CAFO FACILITY INSPECTION REPORT

04/11/2013
SCHEDULED INSPECTION DATE

TIVA Dairy
FACILITY NAME

Photograph 4. View facing east of the southern basins constructed in field No. 1, basin No. 1, and basin No. 2 (refer to Exhibit 1). Note the accumulated solids in the basin, and that the basins did not contain depth markers.

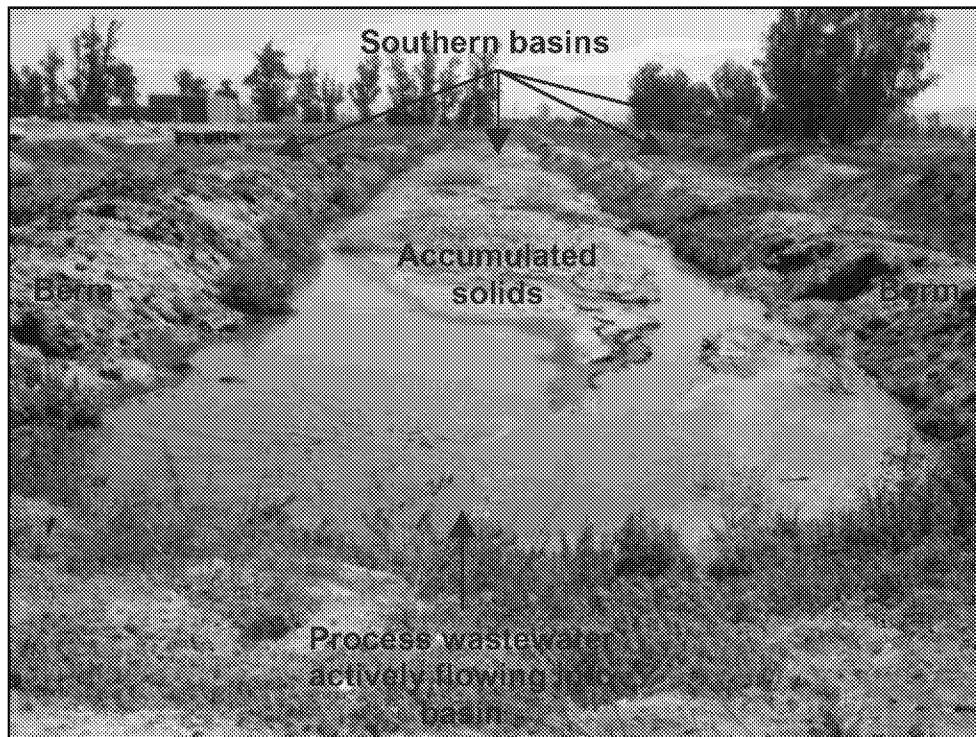
1. Depth markers were not installed in all basins at the Facility as required by Permit Attachment B - Monitoring and Reporting Program, Section I.B.1 (refer to Photos 4 through 7, and 15).

3. The inspector observed, during the inspection, accumulated solids in the basins located in the southern portion of the Facility (refer to Photos 4 and 5). Mr. Vander Meulen stated that all Facility containment structures were last cleaned in 2012, and had been cleaned "a couple times" in the eight (8) years the Facility has been in operation. In addition, the inspector observed pond solids stockpiled on the earthen berms between the basins (refer to Photos 6, 8, and 9). As a result, the overall capacity of the containment structures at the Facility may be diminished. Provision VII.C.3.a of the Permit states that "the discharger shall design, construct and maintain containment structures to retain all wastewater within the facility, including all process wastewater and all precipitation on, and drainage through, manured areas resulting from rainfall up to and including a 25-year, 24-hour rainfall event." The Discharger must design and maintain all containment structures per the EWMP as required by Provisions VII.C.3.a of the Permit.

Photograph 5. View facing east of the southern basins. Process wastewater was actively flowing into the northern-middle basin. Note the accumulated solids in the basin. Also note the basins did not contain depth markers.

Photograph 6. View facing east of the southern basins. Note previously removed basin solids were observed on the berms between the basins. Also note the basins did not contain depth markers and was observed with vegetation growth.

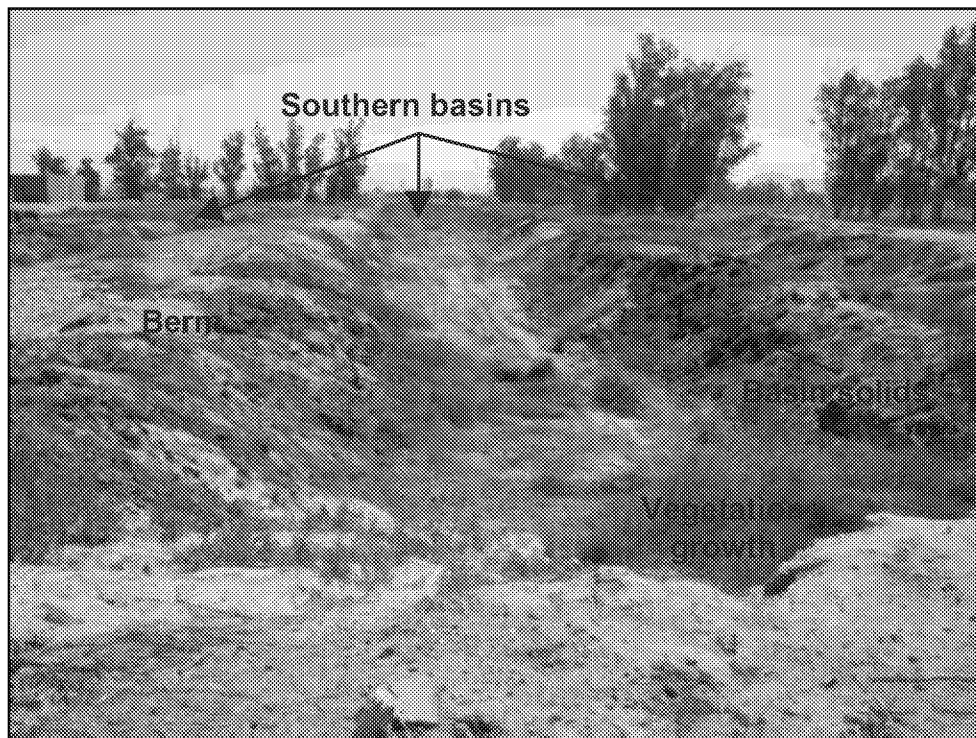
2. The inspector observed, during the inspection, that previously removed basin solids had been stockpiled on the earthen berms of the basins located in the southern portion of the Facility (refer to Photos 6, 8, and 9). Mr. Vander Meulen stated that the southern basins were last cleaned of accumulated solids in 2012. Provision VII.C.5.c of the Permit states "no containment structures shall be constructed of manure, and manure shall not be used to improve or raise existing containment structures."

4. The inspector observed, during the inspection, that vegetation growth potentially affecting the containment structure capacity was observed in all Facility containment structures (refer to Photos 6, 7, 10, 11, and 12). As a result, the overall capacity of the containment structures at the Facility may be diminished. Provision VII.C.3.a of the Permit states that "the discharger shall design, construct and maintain containment structures to retain all wastewater within the facility, including all process wastewater and all precipitation on, and drainage through, manured areas resulting from rainfall up to and including a 25-year, 24-hour rainfall event." The Discharger must design and maintain all containment structures per the EWMP as required by Provisions VII.C.3.a of the Permit.

Photograph 8. View facing northwest of basin solids stockpiled on the earthen berm of the southern-most southern basin.

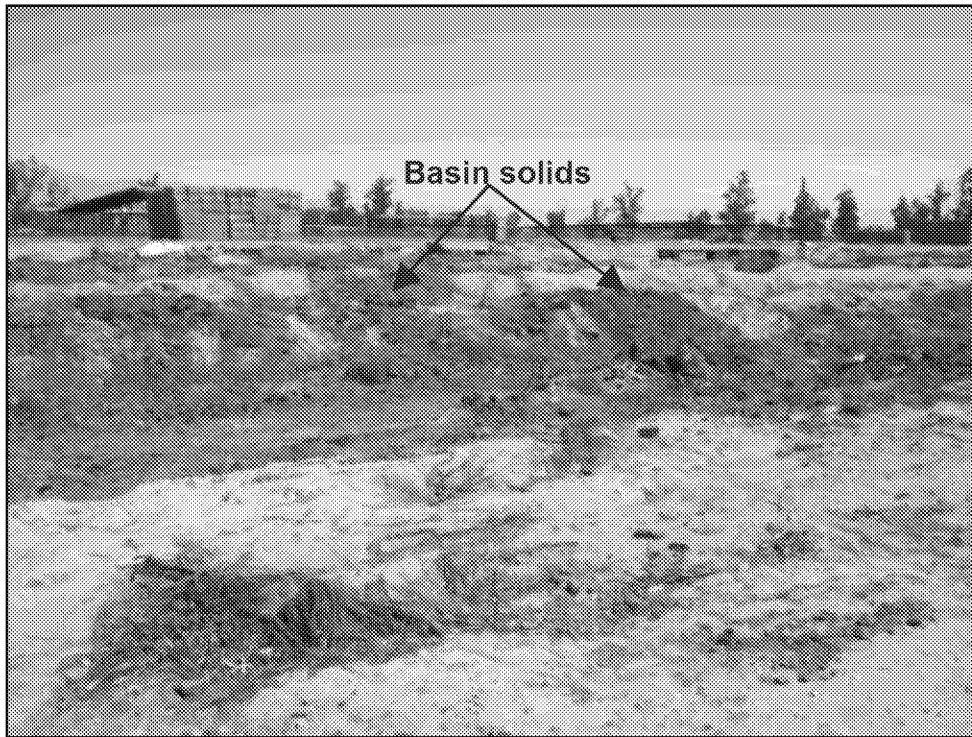
Photograph 9. View facing north of previously removed basin solids stockpiled on the earthen berm of the southern-most southern basin.

Photograph 10. View facing west of vegetation growth and accumulated solids on the east side of the southern basins.

Photograph 12. View facing south of the process wastewater flow pathway from a southern basin into the conveyance ditch along the east side of the Facility. Note the vegetation growth.

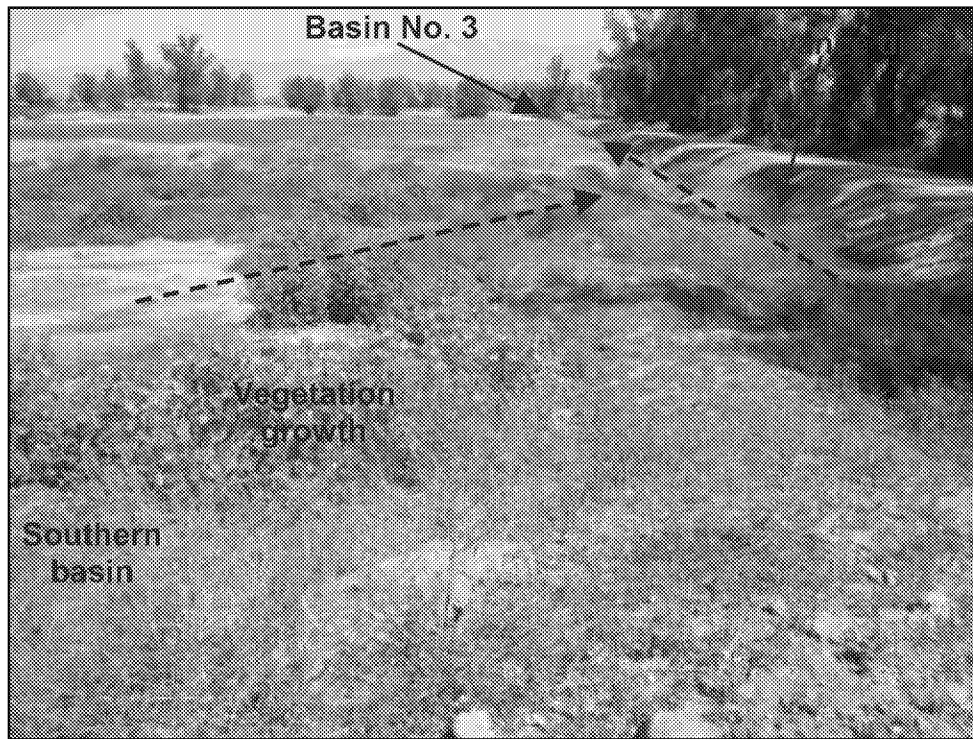
Photograph 13. View facing north of the process wastewater flow pathway from a southern basin into the conveyance ditch along the east side of the Facility. Note the vegetation growth.

Photograph 15. View facing south of basin No. 3 located in the northeast corner of the Facility. Note vegetation growth was observed on the basin embankments. Also note the basin did not contain a depth marker.

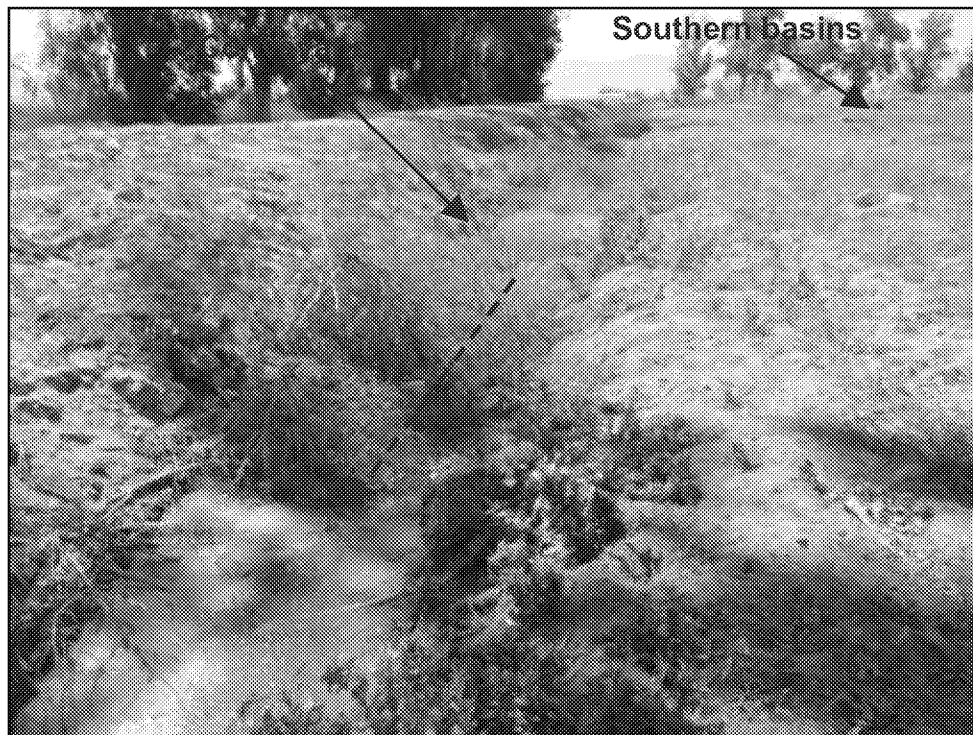
Photograph 16. View facing south of basin No. 3 located in the northeast corner of the Facility. Note vegetation growth was observed on the basin embankments.

Photograph 18. View facing west of skeletal remains and mortality debris on the north side of field No. 3, east of the northern corrals.

Photograph 19. Close-up view of the skeletal remains shown in Photograph 19.

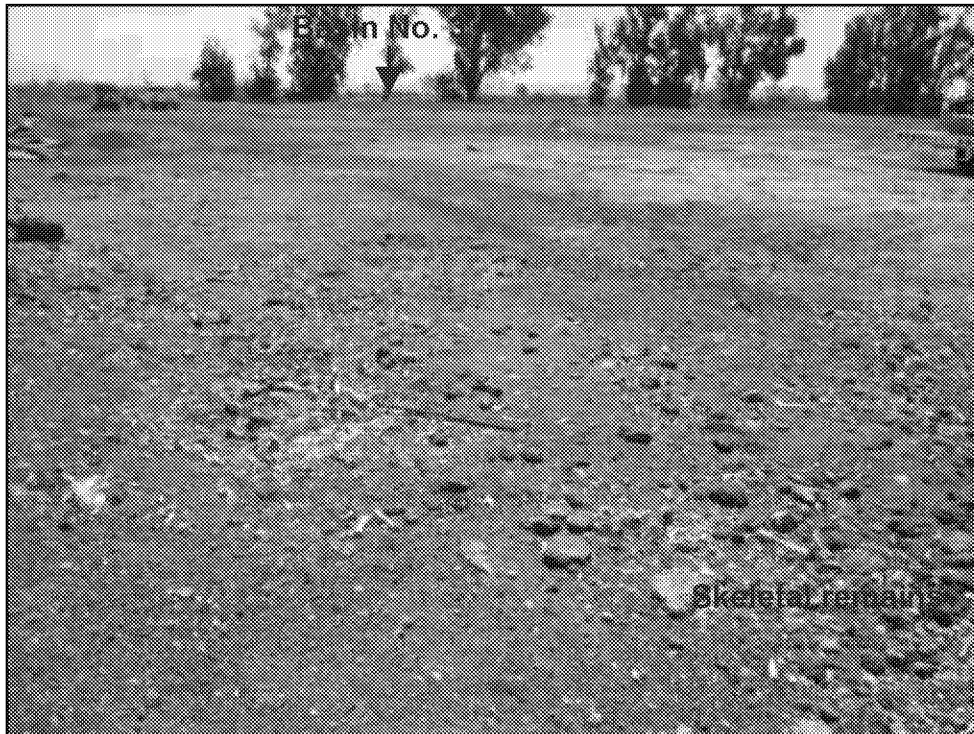
1. The inspector observed, during the inspection, skeletal remains (i.e., livestock mortalities) on the north side of field No. 3, northwest of basin No. 3 (refer to Photos 18 through 22). The skeletal remains appeared to be contained onsite; however, storm water runoff from field No. 3 most likely would flow southeast and enter basin No. 3. Mr. Vander Meulen stated that all skeletal remains are the result of coyotes killing new born calves and dragging them east into field No. 3. Discharge Prohibition IV.F of the Permit states "the disposal of any mortality in any process wastewater system is prohibited. Mortalities shall be handled in such a way as to prevent the discharge of pollutants to waters of the state."

Photograph 20. View facing east skeletal remains and mortality debris on the north side of field No. 3, shown in Photographs 18 and 19, west of basin No. 3.

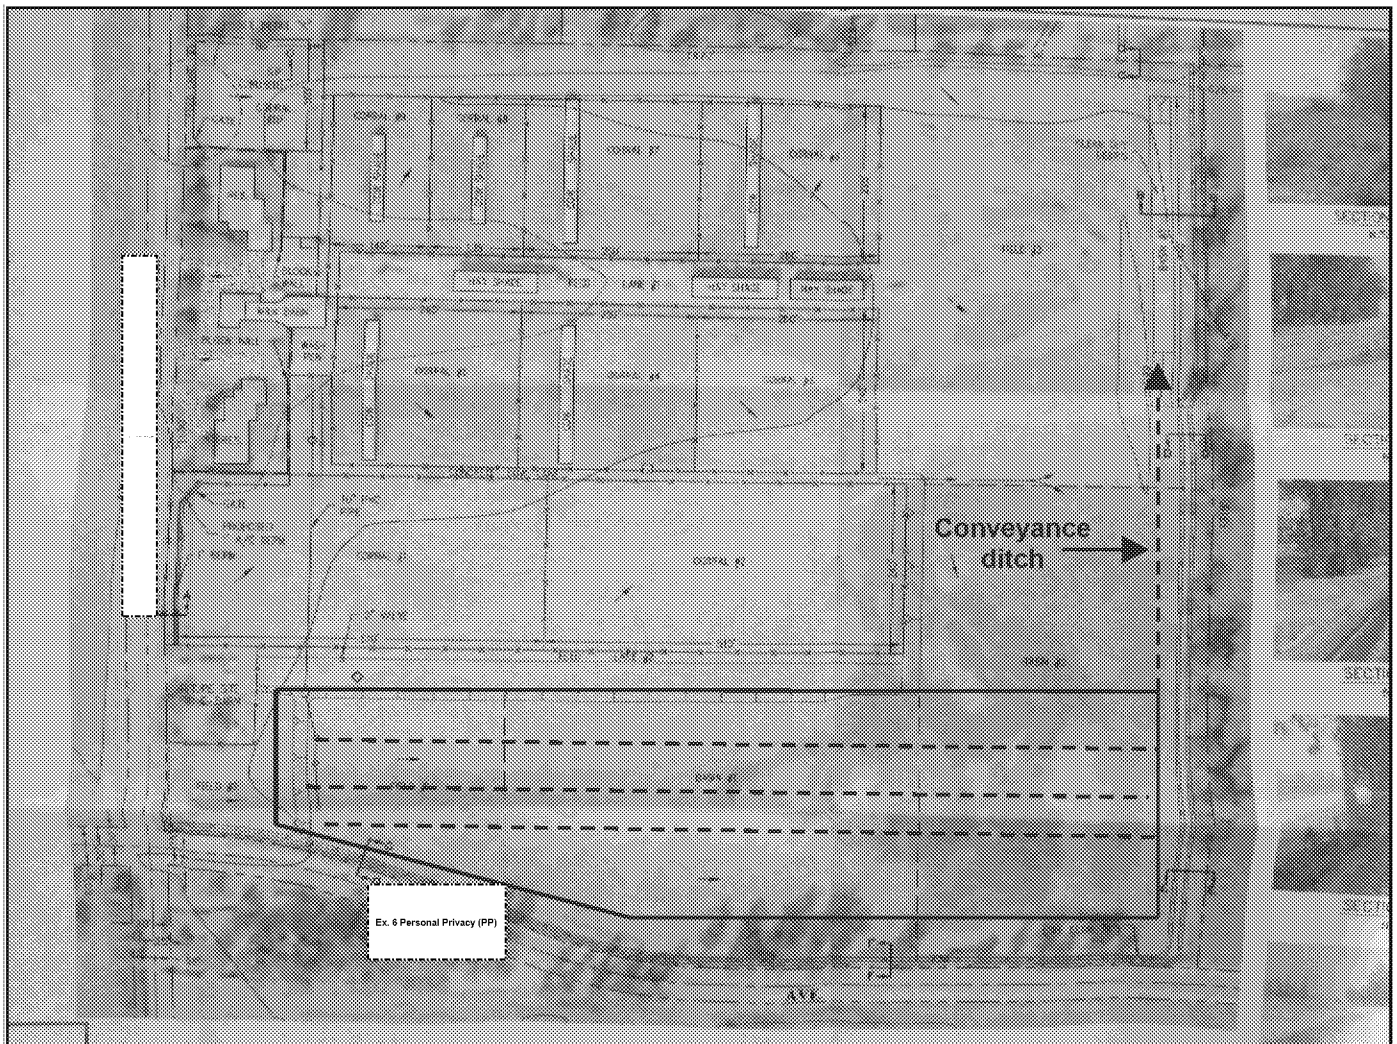
2. The EWMP was not representative of current Facility conditions at the time of the inspection as required by the Permit. Specifically, the approved EWMP and Site Plan identifies that process wastewater is land applied via four (4) check valves onto field No. 1 located in the southwestern portion of the Facility, and flows south through basin Nos. 1 and 2. The inspector observed, during the inspection, that four (4) additional basins had been constructed in field No. 1, basin No. 1, and the southern half of basin No. 2 (refer to Exhibit 1). East/west earthen berms had been constructed creating four (4) additional rectangular basins (refer to Photos 4 through 7, and 10). All four basins flow into a conveyance ditch on the east side of the Facility that flows north into basin No. 3 located in the northeast corner of the Facility (refer to Photos 12, 13, and 14). The conveyance ditch was also not identified on the approved EWMP or Site Plan. Mr. Vander Meulen stated that the Facility had always had the basins located in the southern portion of the Facility, and was unaware of the discrepancies with the EWMP and Site Plan. As a result of the additional basins and process wastewater conveyance ditch, the Discharger was not fully implementing the approved EWMP. Provision VII.C.3.b of the Permit states that "the discharger shall develop and fully implement an Engineered Waste Management Plan (EWMP) acceptable to the Executive Officer." The Discharger shall fully implement the EWMP as required by Provision VII.C.3.b of the Permit. This finding was previously identified during an inspection conducted on January 19, 2012.

Exhibit 1. TIVA Dairy approved EWMP Site Plan. Note four (4) east/west basins were constructed on the south side of the Facility in field No. 1, basin No. 1, and the southern half of basin No. 2. It should be noted that these additional basins were not in accordance with the approved EWMP and Site Plan.
